ADMINISTRATIVE AMENDMENT (PD) ADD2017-00098(A)

ADMINISTRATIVE AMENDMENT
LEE COUNTY, FLORIDA

Portofino Vineyards
Villages of San Carlos Parcels B, C, D & E
ADD2017-00098
Schedule of Deviations and Written Justification
Revised December 13, 2017

Exhibit B

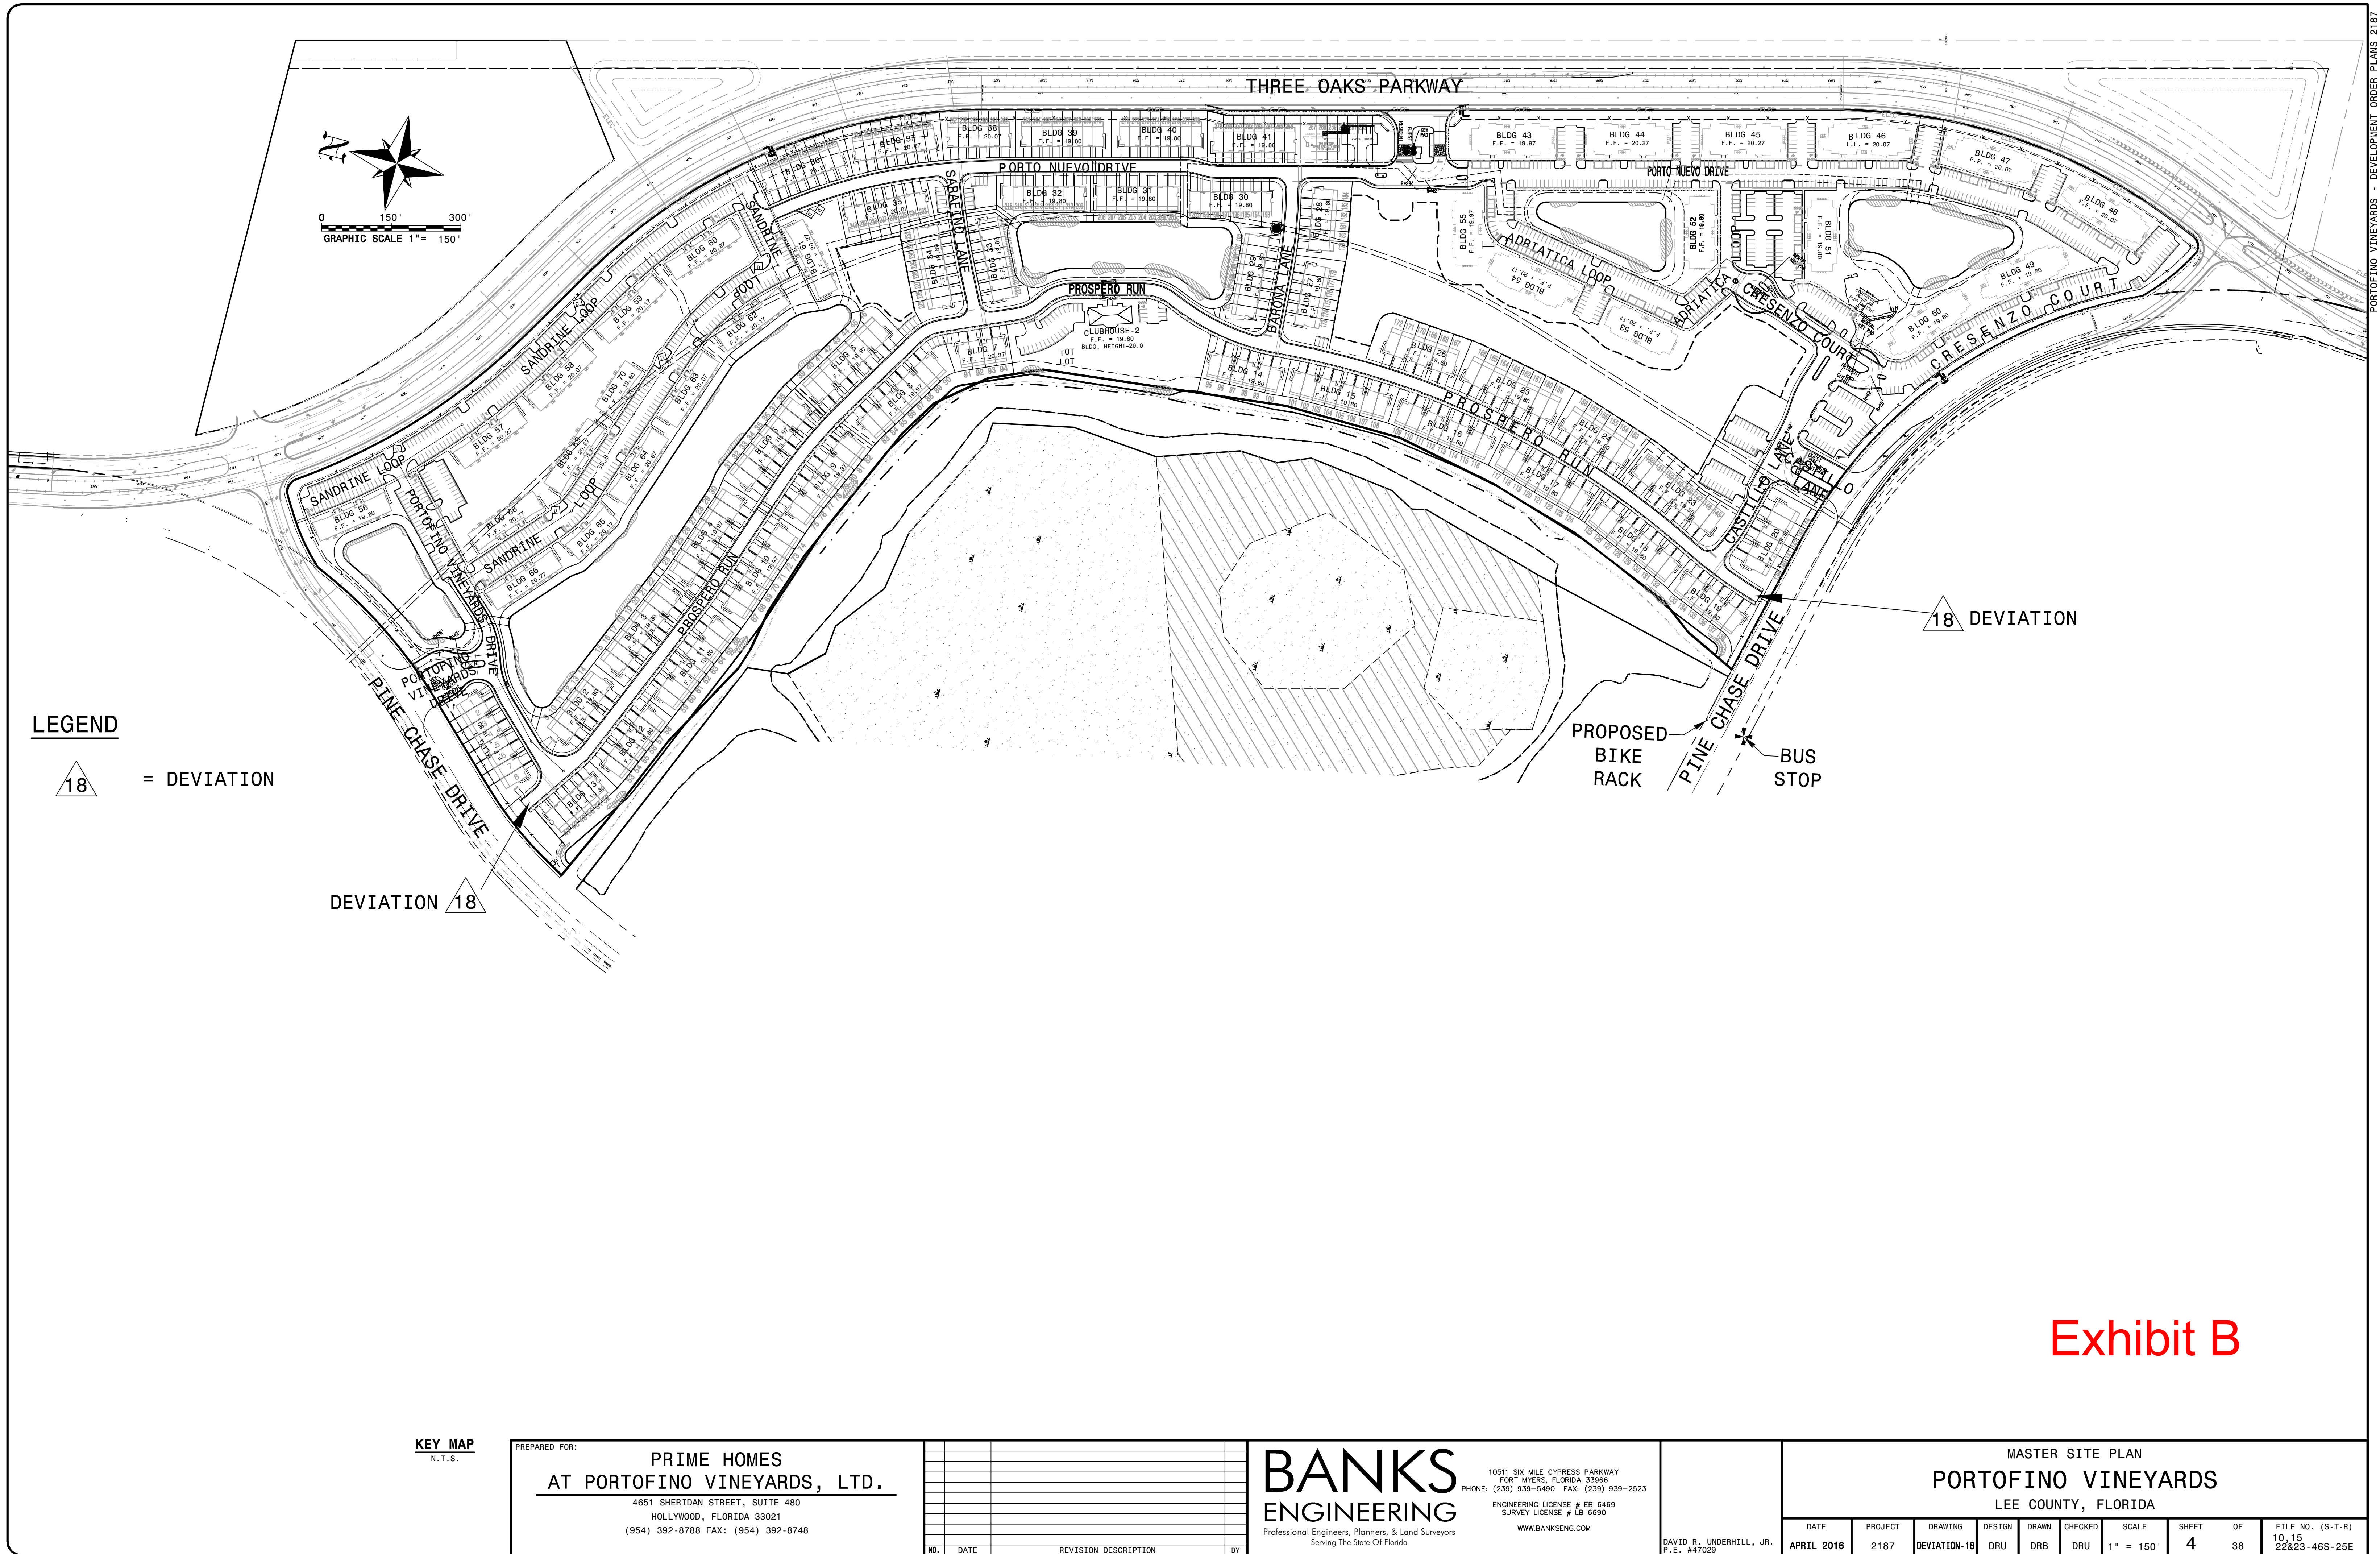
- **Deviation 17 has been WITHDRAWN.**
- **Deviation 18 requests relief from LDC Sec. 10-296(p)(1), which requires dead end streets to end by a circular turnaround; to eliminate this requirement.**

5. Deviation 18 is hereby approved for those specific locations noted on Exhibit B. These approved dead ends must be designed to not exceed the maximum limits provided in the Florida Fire Prevention Code and height restrictions for signage and landscaping in these areas due to the platform/bucket which extends several feet over the front bumper of the 100 foot tower truck. The landscape plans and civil plans submitted as part of the local development order must contain general notes referenced to the subject dead ends, referencing the Fire Department height restrictions.

TYPICAL LAKE CROSS SECTION
FOR EXISTING LAKES 3, 4 & 5

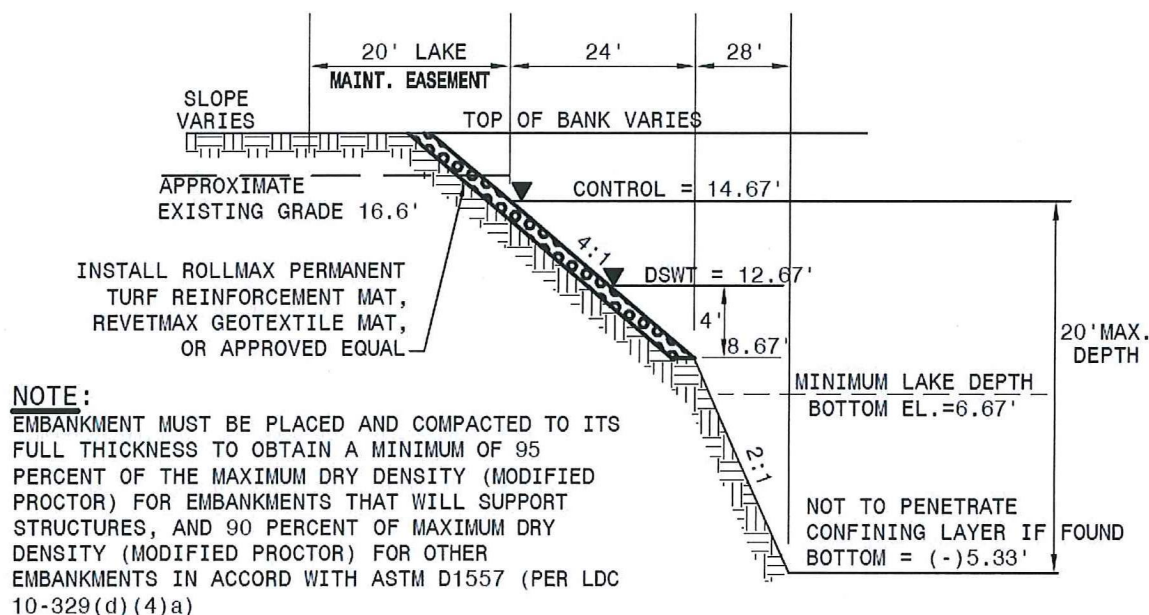
DEVIATION 15: From LDC Section 10-329(d)(4) which requires the banks of excavations to be sloped at a ratio not greater than six horizontal to one vertical; to allow a slope no steeper than four to one for 3 of the existing lakes (lakes 3, 4 & 5 on proposed DO plans) with enhanced slope protection measures by reinforcement per below cross-section and providing double the required littoral plantings as shown on the attached landscape plan.

JUSTIFICATION: The project originally received development order approval on October 29, 2007 pursuant to DOS2006-00115. Upon approval of the D.O. and vegetation removal permit, site construction commenced. Site work was subsequently stopped due to economic conditions. At the time site work was halted, these lakes had

been constructed in compliance with the D.O. approval (see aerial below and lakes labeled 3, 4 & 5). On June 23, 2009, the Land Development Code was amended by Ordinance 09-23 which changed the design standards for new excavation bank slopes from a ratio of four horizontal to one vertical to six horizontal to one vertical. The applicant proposes the following enhanced slope protection measures which will prevent erosion and scouring: enhanced littoral plantings by doubling the required amount in combination with installation of RollMax permanent turf reinforcement mat, RevetMax geotextile mat or approved equal. The proposed littoral planting plan is attached. Administrative deviations for lakes designed and approved by prior development orders have been previously requested and approved from the required six to one slope to allow a slope no steeper than four to one, consistent with the existing approvals and subject request. The alternative proposed is based on sound engineering practices and is no less consistent with the health, safety and welfare of abutting landowners and the general public than the standard from which the deviation is being requested.

Lake 4

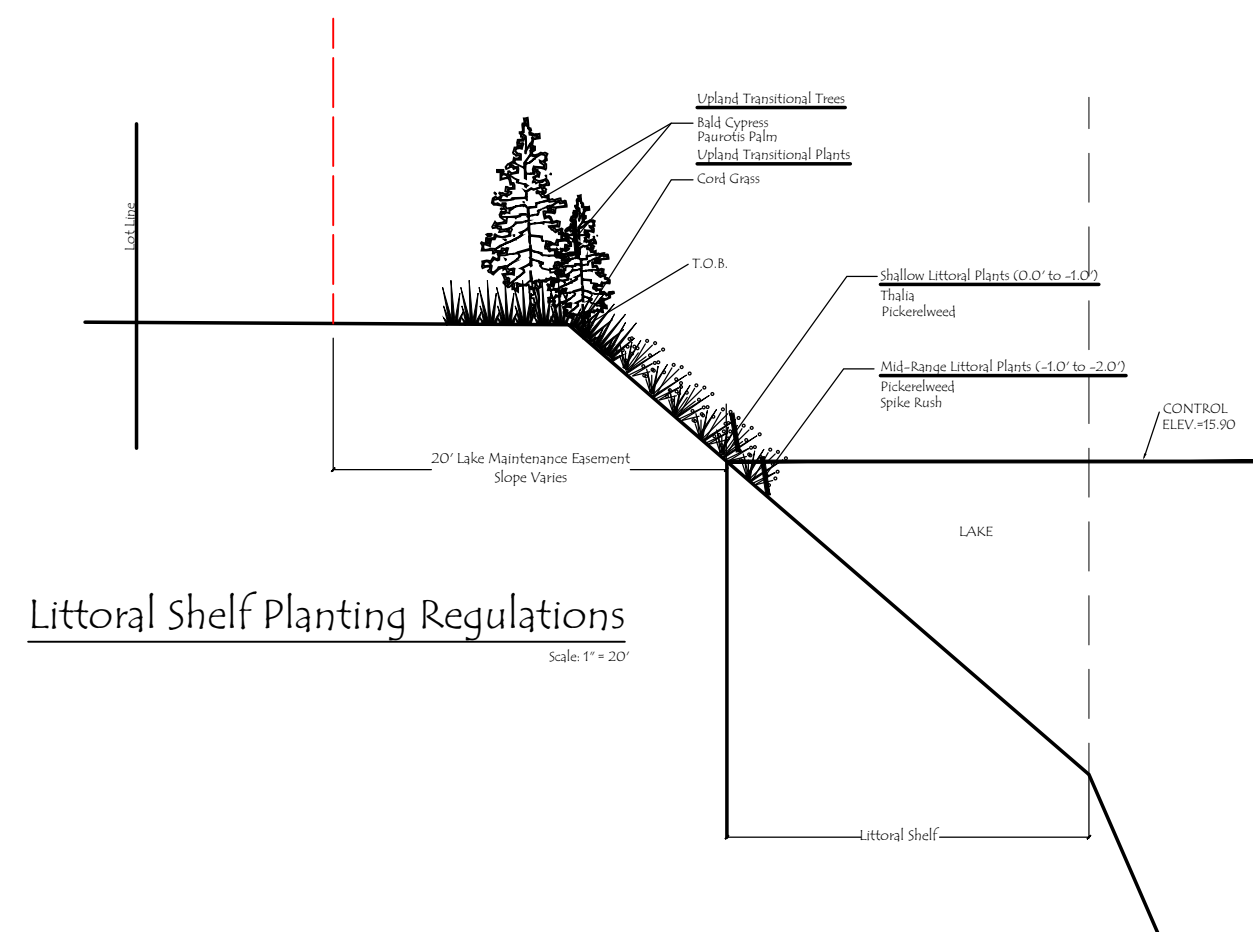
DEVIATION 16: A request for relief from the Lee County Land Development Code Section 10-418(2) planted littoral shelf criteria which requires 25 percent of the linear feet of the shoreline to be a planted littoral shelf to be designed to include a 20 foot wide littoral shelf extending

LAKE #4	(735 L.F. OF SHORELINE)	
LITTORAL PLANTINGS REQUIRED	_____	918 PLANTS
(5 HERBACEOUS PLANT PER 4 L.F. OF LAKE EDGE)		
DEEP LAKE TREE REQUIRED	_____	8 TREES
(1 DEEP LAKE TREE PER 100 L.F. OF LAKE EDGE)		
 LITTORAL PLANTINGS PROVIDED	 _____	 486 PLANTS (LINERS)
		1,350 PLANTS (LINERS) = (135 3 GAL SHRUBS/24" MIN HGT. =1,350 LINERS)
		1,836 TOTAL PLANTS
 DEEP LAKE TREES PROVIDED	 _____	 8 DEEP LAKE TREES (10' MIN HGT.)
